TRANS/WP.29/2001/31
12 April 2001

World Forum for Harmonization of Vehicle Regulations (WP.29)
(One-hundred-and-twenty-fourth session,
26-29 June 2001, agenda item 4.2.16.)

PROPOSAL FOR DRAFT SUPPLEMENT 1 TO REGULATION No. 100

(Battery electric vehicles)

Figure 7.1
Determination of hydrogen emissions
during the charge procedures of the traction battery.

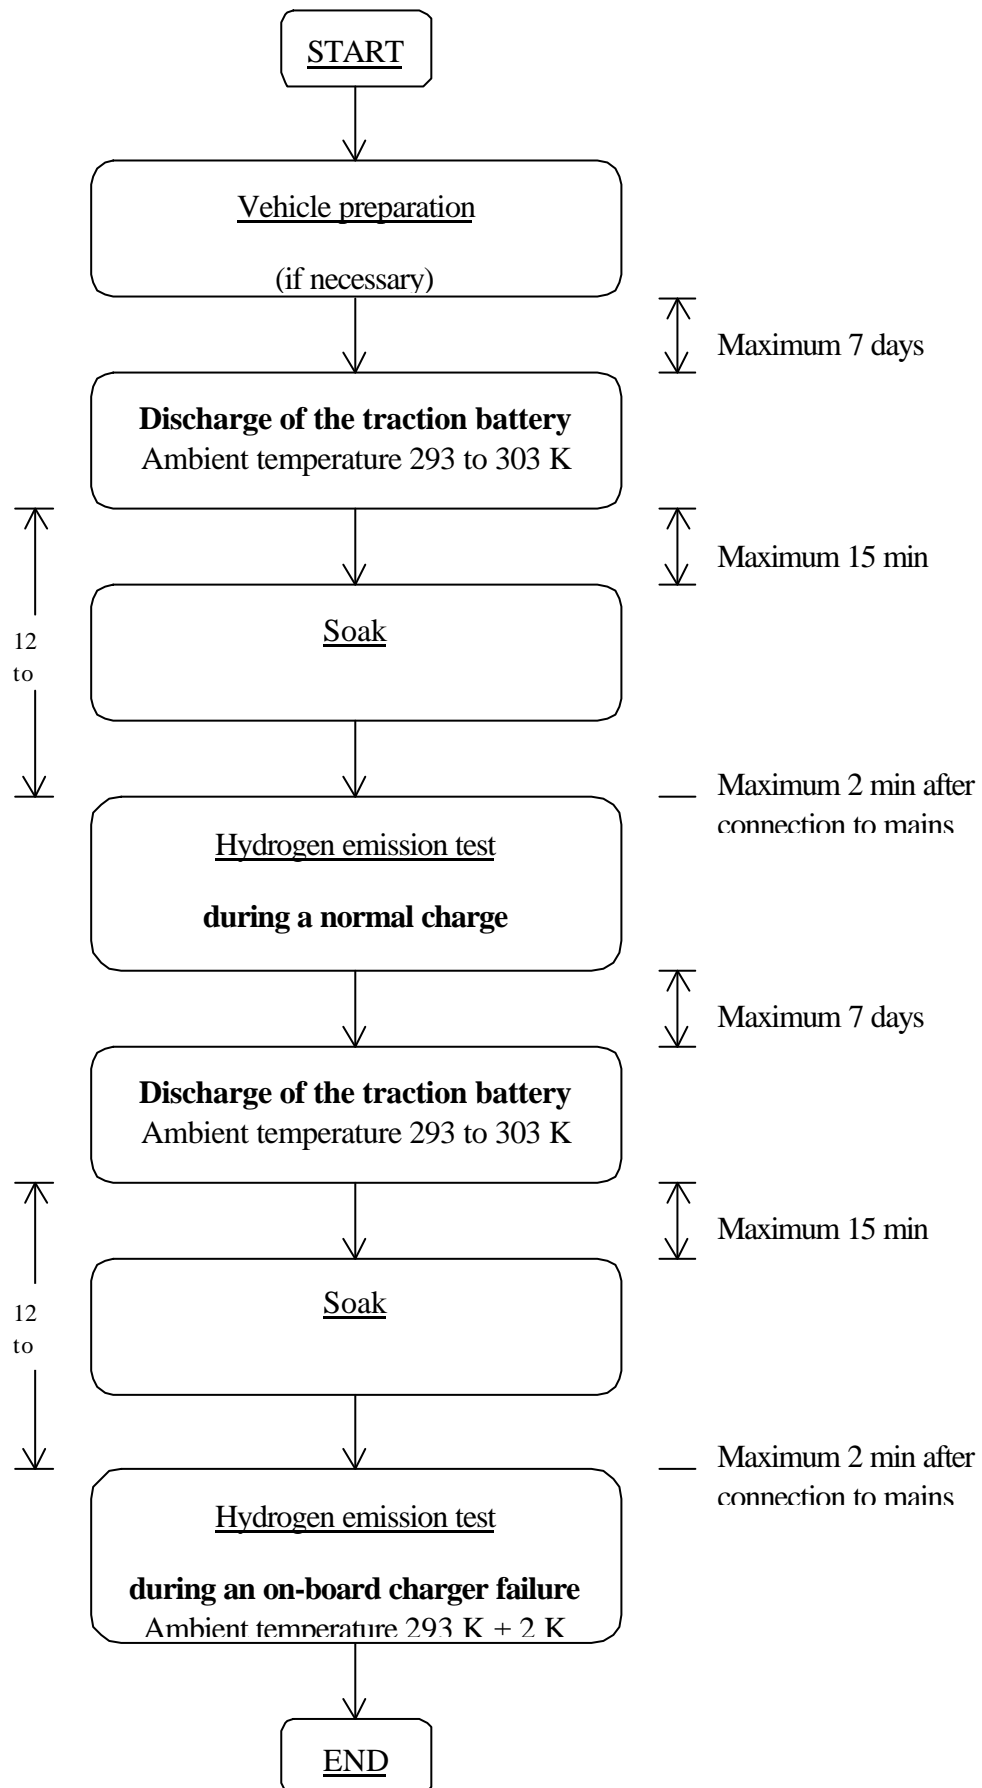
The hydrogen emission test (Figure 7.1) is conducted in order to determine hydrogen emissions during the charge procedures of the traction battery with the on-board charger. The test consists in the following steps:

- (a) vehicle preparation,
- (b) discharge of the traction battery,
- (c) determination of hydrogen emissions during a normal charge,
- (d) determination of hydrogen emissions during a charge carried out with the on-board charger failure.
